Project-Level Conformity Determination Documentation for
Interstate 5/Louise Avenue Interchange Improvement Project
San Joaquin County

San Joaquin Council of Governments (SJCOG), on behalf of the City of Lathrop, is providing the final documentation for PM_{2.5} and PM₁₀ Hot-spot Conformity Assessment for Interstate 5/Louise Avenue Interchange Improvement Project (FTIP ID SJ07-2005) located in San Joaquin County.

San Joaquin Valley (SJV) Hot Spot Checklist for Interagency Consultation

A. Project Name and Number: Interstate 5/Louise Avenue Interchange Improvement Project

Figure 3: Diverging Diamond Interchange Design

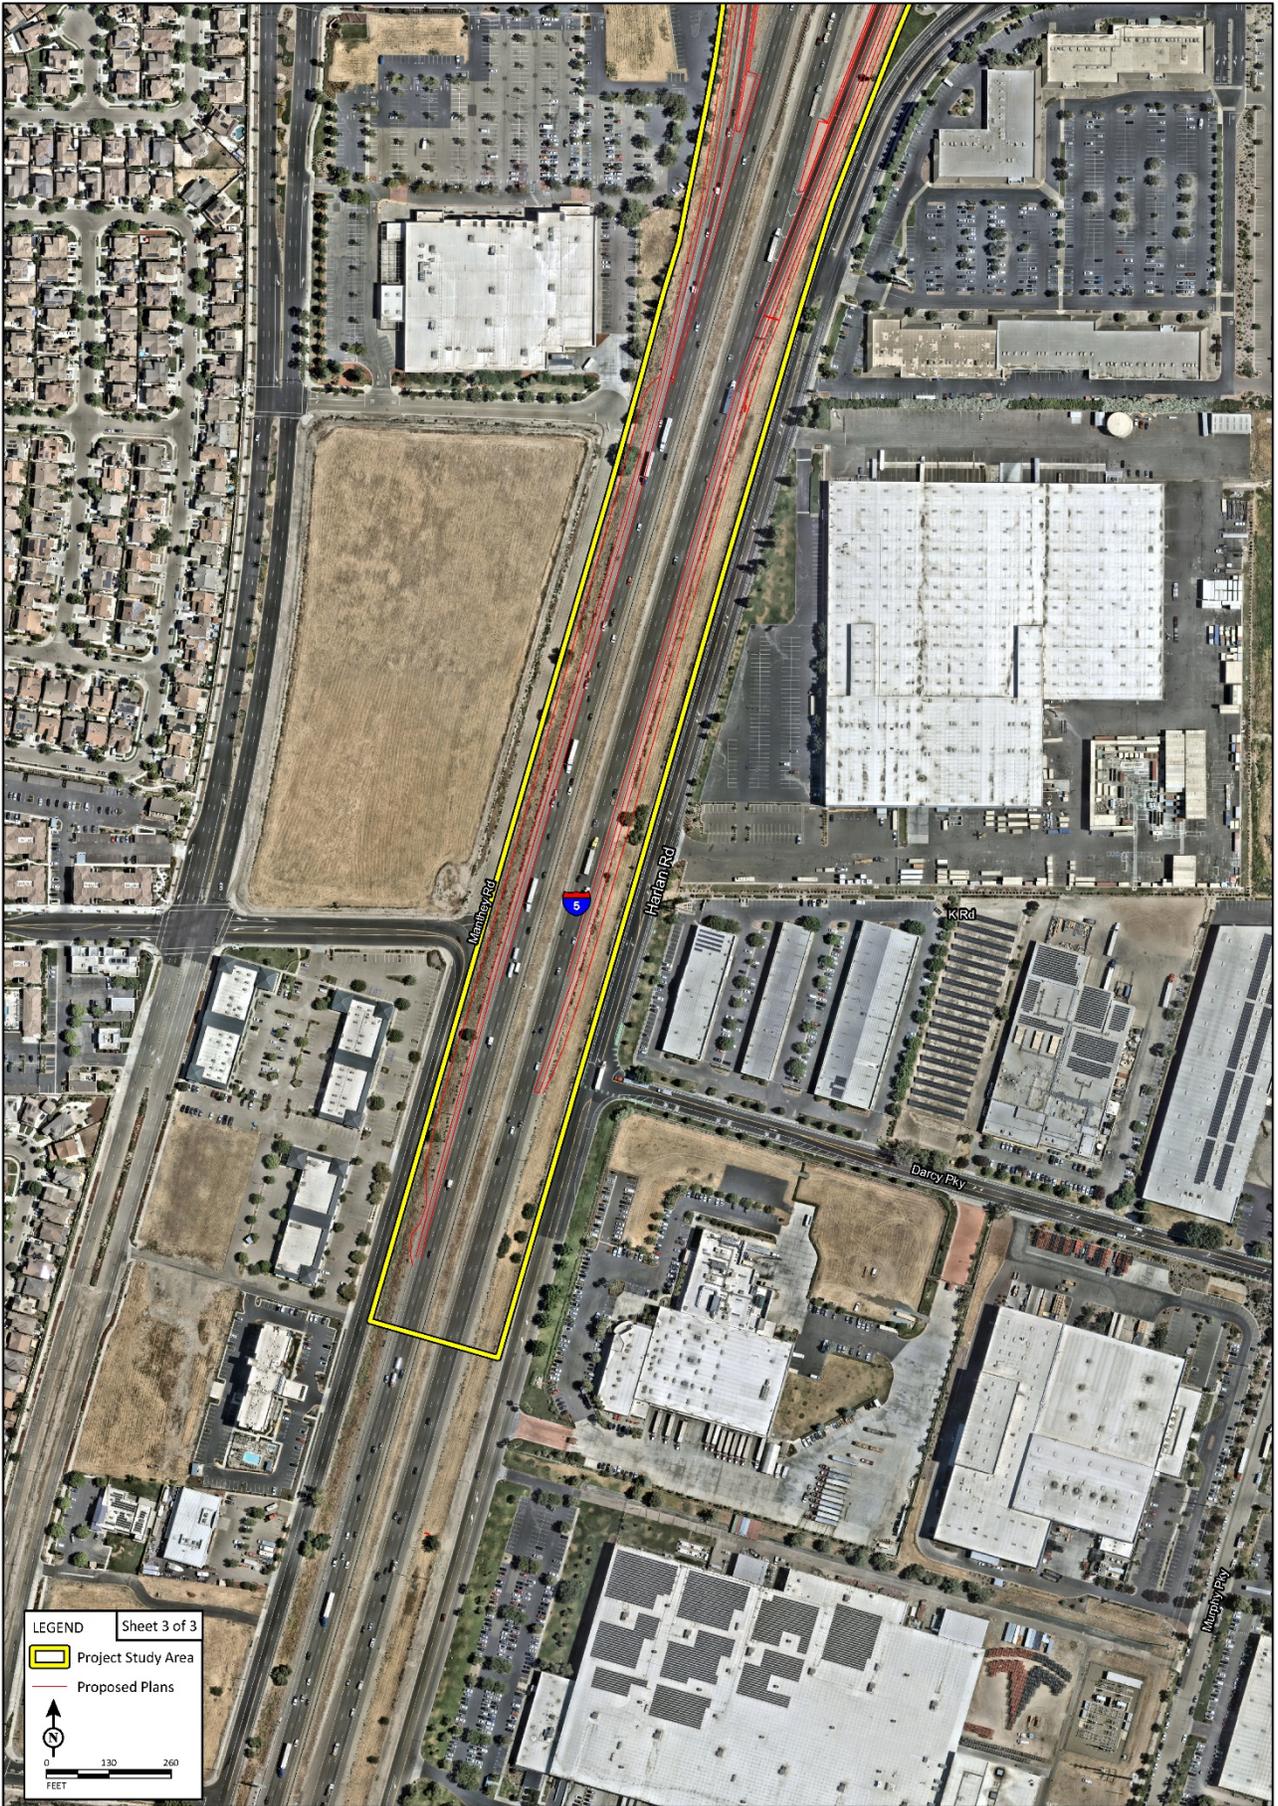
EPA asked for clarification on whether the project involves converting the existing diamond interchange above Louise Avenue into a converging diamond interchange (DDI). EPA also requested confirmation that the project does not include any capacity increase — noting that while auxiliary lanes are proposed between Louise Avenue and Lathrop, no new through lanes appear to be added.

Caltrans D6 Comment: Caltrans inquired whether the new DDI will go over or under the freeway and confirmed that the project appears to maintain the existing structure. Caltrans also requested clarification on whether the project will affect traffic flow or level of service (LOS) on I-5.

The DDI will remain under I-5, consistent with the existing configuration. The project does not change the number of through lanes on I-5. While auxiliary and acceleration lanes will be added to improve local weaving and merging operations, the overall mainline LOS is expected to remain similar under both build and no-build conditions, with minor localized improvements in certain segments.
